The Hills Resort Limited
C/- Jeff Brown and Christine Edgley
Brown & Company Planning Group
PO Box 1467, Queenstown
9348

PRIVATE PLAN CHANGE REQUEST TO PROPOSED DISTRICT PLAN CHAPTER 47
THE HILLS RESORT ZONE
REQUEST FOR FURTHER INFORMATION

Figure 19-1. Excerpt of the proposed Structure Plan with the Indicative Trail, and orange shape identifying the diversion of the Trail through 113 Hogans Gully Road and realigned access onto McDonnell Road adjacent to the Arrowtown Retirement Village.

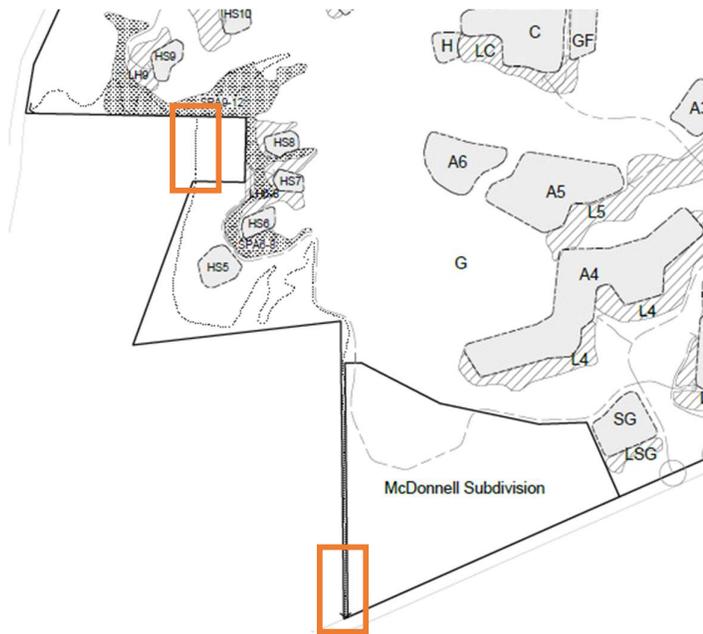
- 18. Please identify any adverse effects on the Trail users experience and whether the existing indicative entry point onto McDonnell Road is more appropriate from both a safety perspective and a user experience perspective.
- 19. Part of the proposed indicative Trail is located outside the THRZ and Structure Plan Area where it crosses in front of 113 Hogans Gully Road which is zoned Wakatipu Basin Rural Amenity Zone. Can you identify any impediments to subdivision and development (i.e. in the PDP provisions) of part of the THRZ Structure Plan area applying to a zone other than THRZ?

Figure 20-3. Excerpt of Plan Change Document 5 – Appendix 3. Red mark-up illustrating the proposed amendments.

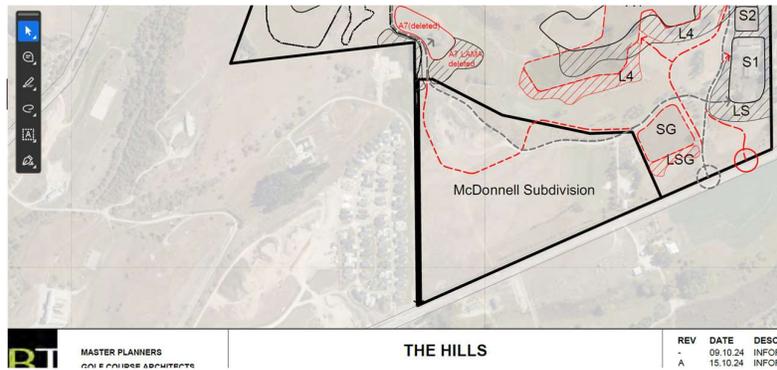
Figures 1-5 below indicate that a part of the proposed amendment to the Structure Plan proposing a road from McDonnell Road (via the existing access) to Homesites 5-8 road appear to be located within the adjoining Site zoned Wakatipu Basin Lifestyle Precinct, on the property legally described as Lot 2 Deposited Plan 392663.

The proposed new road access appears to encroach into the adjoining Wakatipu Basin Lifestyle Precinct zoning.

Note that the solid black line surrounding the area titled ‘McDonnell Subdivision’ does not appear to adhere to the existing cadastral boundaries nor the existing The Hills Resorts Zone Structure Plan.

- a. Is that part of Lot 2 Deposited Plan 392663 currently zoned Wakatipu Basin Lifestyle Precinct proposed to be rezoned and included in THRZ?
- b. If the answer to the above is no, can you identify any impediments to subdivision and development (i.e. in the PDP provisions) of a part of the THRZ Structure Plan area applying to a zone other than THRZ?
- c. Please clarify what is meant by the identification of Lot 2 Deposited Plan 392663 as the 'McDonnell Subdivision'. Is this relevant in any way to THRZ and should this title be included on the THRZ Structure Plan?

Figure 20-5. Excerpt of Plan Change Document 2 Proposed Structure Plan (Clean Version) showing the proposed road into what is understood to be Wakatipu Basin Lifestyle Precinct zoning.

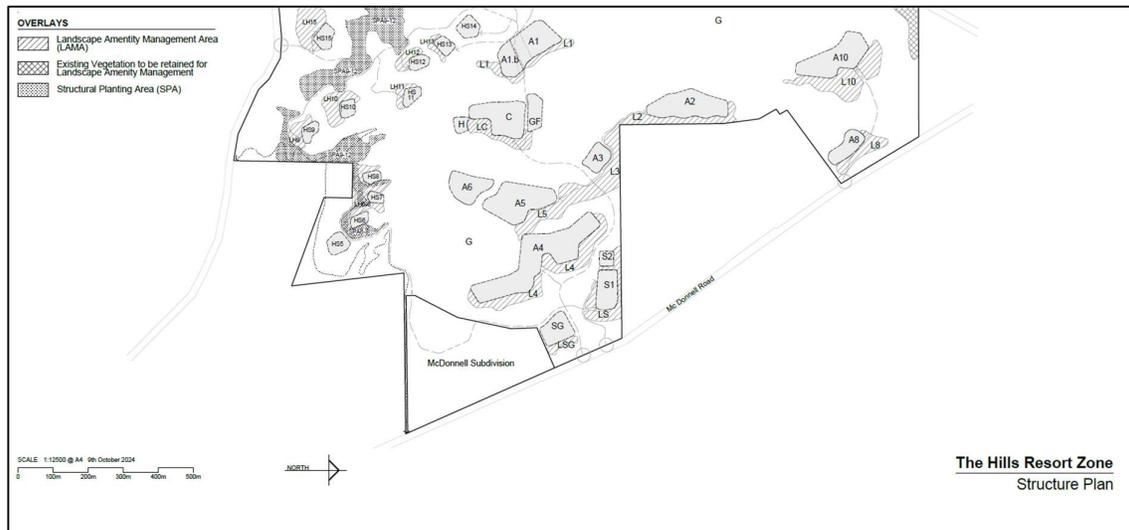
Therefore, it appears as though development activities would encroach outside the existing extent of THRZ.
